**Cimarron Environmental Response Trust
Response to April 7, 2016 NRC
Acceptance Review of
Cimarron Facility Decommissioning Plan**

Re: Docket No. 70-925; License No. SNM-928
Response to April 7, 2016 Letter on Cimarron Decommissioning Plan Acceptance Review

Cimarron Environmental Response Trust
 OVERALL SITE PLAN AND SHEET LAYOUT KEY

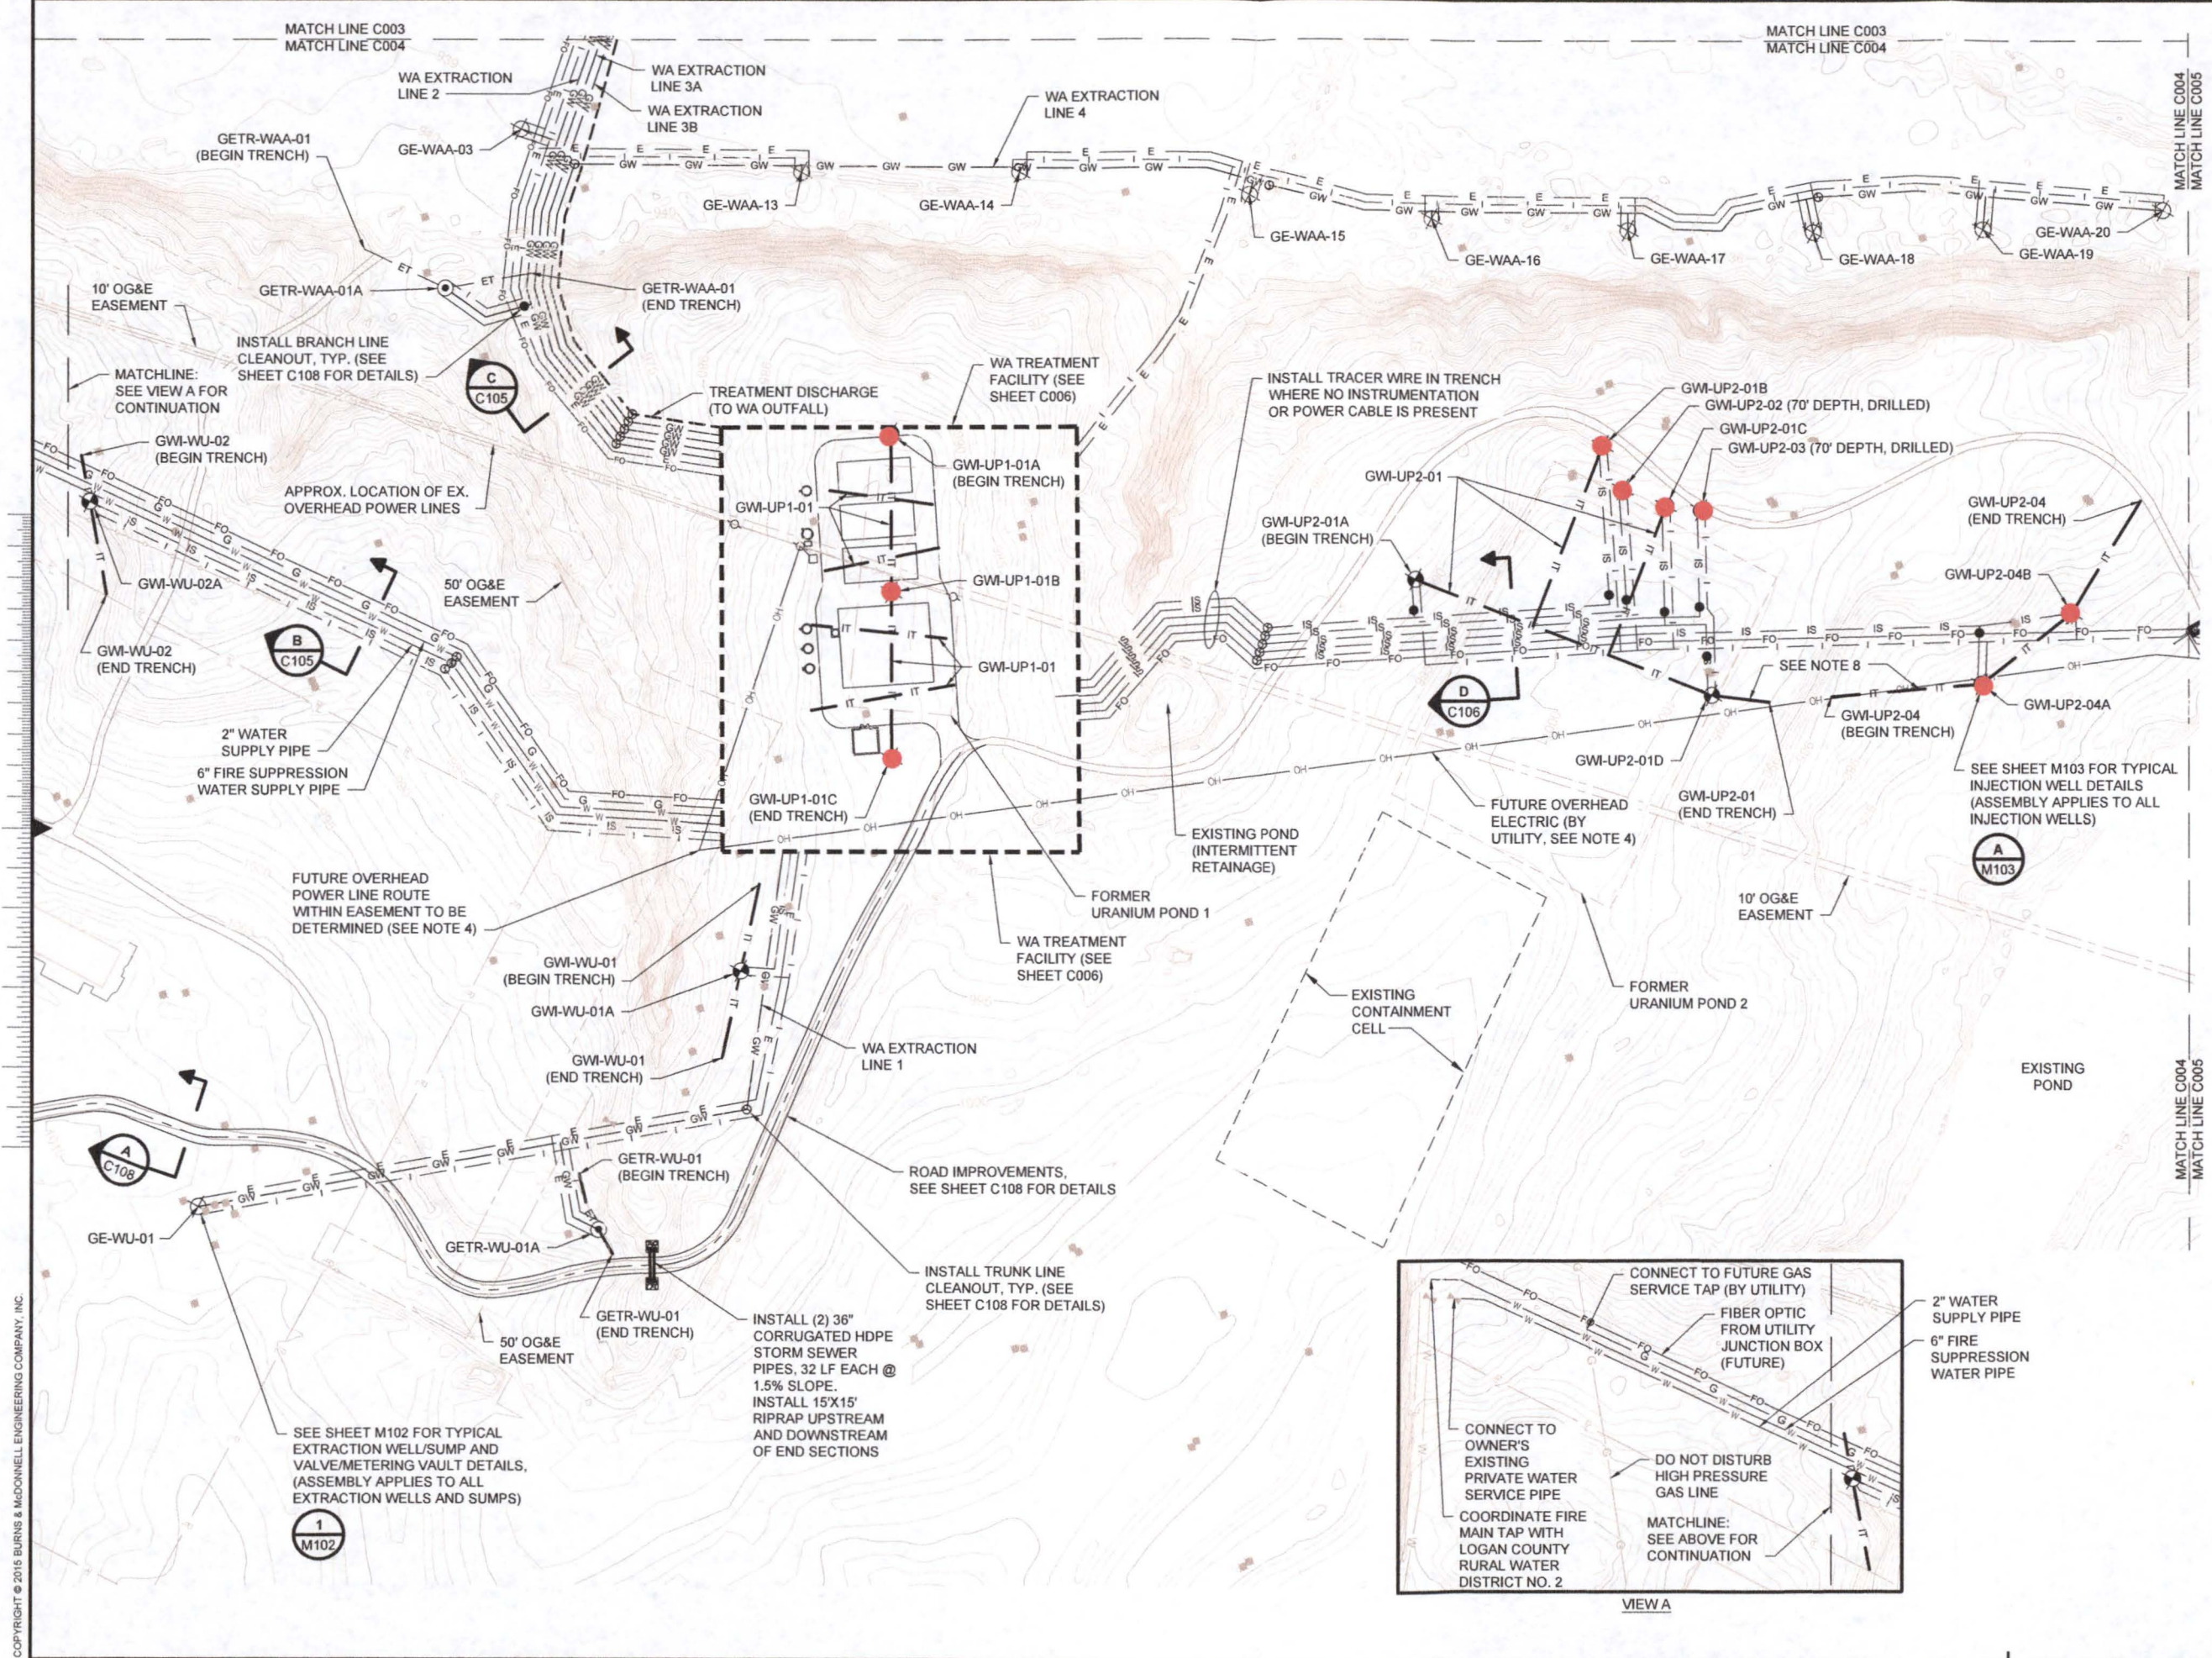
Injection of treated water will occur within the areas identified on BMCD-GWREMEDI-C002 as "C004" and "C005". All of the injection infrastructure located in C004 lies within the northwest quarter of Section 12, T16N, R4W. All the injection infrastructure located in C005 lies within the northeast quarter of Section 12, T16N, R4W. The level of detail on this drawing is not sufficient to locate each injection trench and well. Drawings BMCD-GWREMEDI-C004 and BMCD-GWREMEDI-C005 are also enclosed to provide a more detailed picture of the groundwater remediation infrastructure in these two areas. For your convenience, I have annotated the locations of injection wells by placing a red dot on each one.
